LINE	QUANTITY	UOP	CAT. NO.	ITEM NUMBER	UNIT PRICE	AMOUNT
				ADDENDUM NO. 1		
				THIS ADDENDUM IS ISSUED TO:		
				1) EXTEND THE BID OPENING DATE AND TIME.		
				2) PROVIDE TECHNICAL QUESTIONS & ANSWERS/CLARIFICATIONS		
				3) PROVIDE THE ATTACHED REVISED SPECIFICATIONS AND DRAWINGS (2, 5, 9, 10, 17, 19, AND 20). ELECTRONIC VERSIONS OF THE DRAWINGS ARE AVAILIABLE IN THE ATTACHED FILE, AND BY CONTACTING CANDICE STONE AT: 304-457-4588 EXT 43288 OR 304-457-3219.		
				4) PROVIDE THE ATTACHED REVISED PRICING PAGES.		
				5) PROVIDE THE ATTACHED MANDATORY PRE-BID SIGN IN SHEET		
				***** END ADDENDUM NO. 1 *****		
0001	1	JB		962-73		
				RECLAMATION: RESTORATION OF LAND

Addendum Number: 01

Addendum #1 – Questions and Answers
Clarifications/Corrections to drawings and specifications
DEP16299
Ed-E Development Company Inc.
Permit # S-1032-86

Drawings revised for this project were 2, 5, 9, 10, 17, 19 and 20. Revised drawings have the designation "R" such as 2-R. These drawings are available in PDF format upon request from Candice Stone at 304-457-4588, ext. 43288 or 304-457-3219.

CONSTRUCTION SIGN DETAILS
SCALE: NONE
DATE: MAY 2013

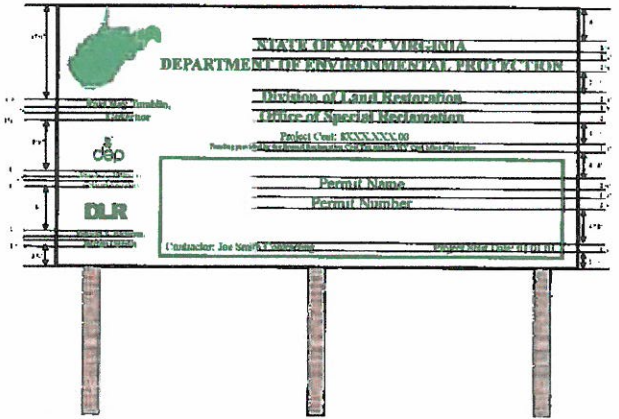
CORRECTION: Patricia A. Hickman Interim Director NOT Ken Ellison Director see Construction Sign Details (20-R)

AQUA-FIX BUILDING MODIFICATION DETAILS

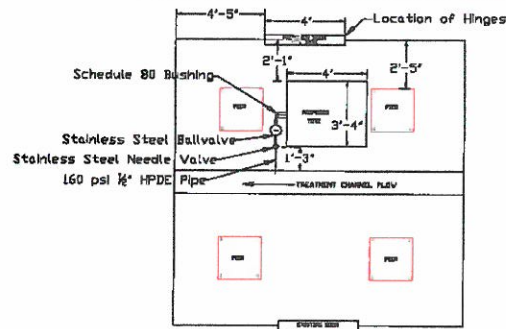
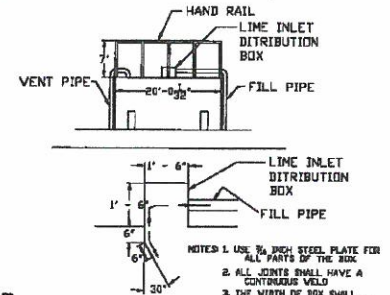
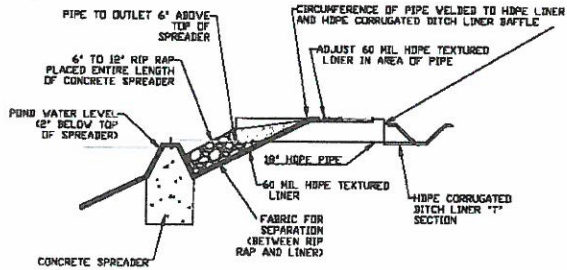
CORRECTION: Aqua-Fix Building Modification Details drawing (10-R). Note #2: Top of tote shall be fitted with a 2" schedule 40 pipe and a 2" female CAM-LOC fitting orientated horizontally as to ensure safe filling of tote. Pipe secured to tote using a bulk head fitting.

CONCRETE SPREADER DETAILS
SCALE: NONE
DATE: MAY 2013

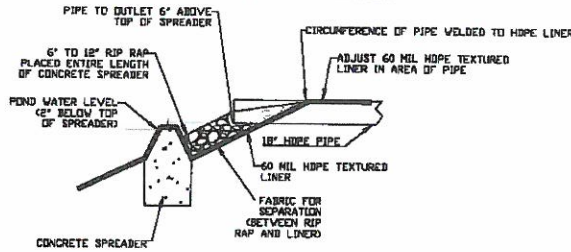
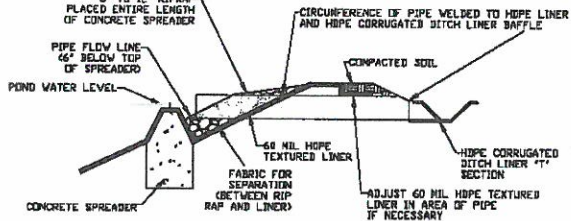
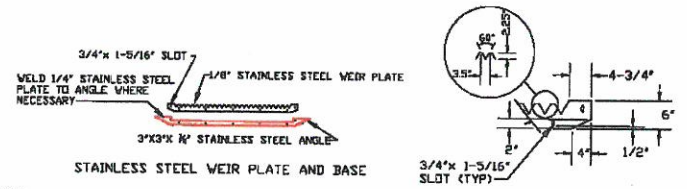
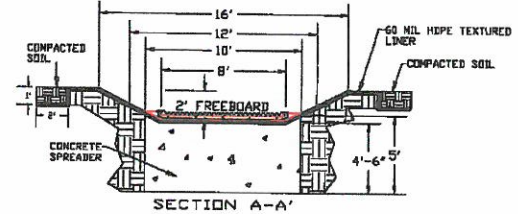
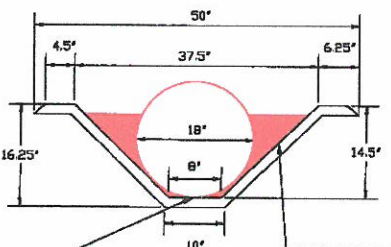
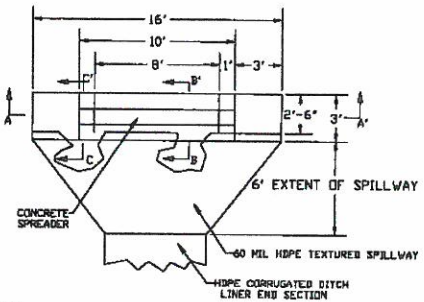
CLARIFICATION: Table indicating inlet and outlet types for each pond, as given at pre-bid conference, is located on the Miscellaneous Pond Details drawing (5-R). The Concrete Spreader type designations are found on Concrete Spreader Details drawing (9-R).

CLARIFICATION: The HDPE Sheet welded to corrugated ditch liner bulkhead, and associated labor shall be incidental to and included in HDPE Corrugated Ditch Liner. See Concrete Spreader Details drawing (9-R).

CLARIFICATION: Distance of HDPE channels from ponds are dependent upon type of concrete spreader for that individual inlet or outlet. See Miscellaneous Pond Details drawing (5-R), Concrete Spreader Details drawing (9-R) and revised Overview Map (2-R).
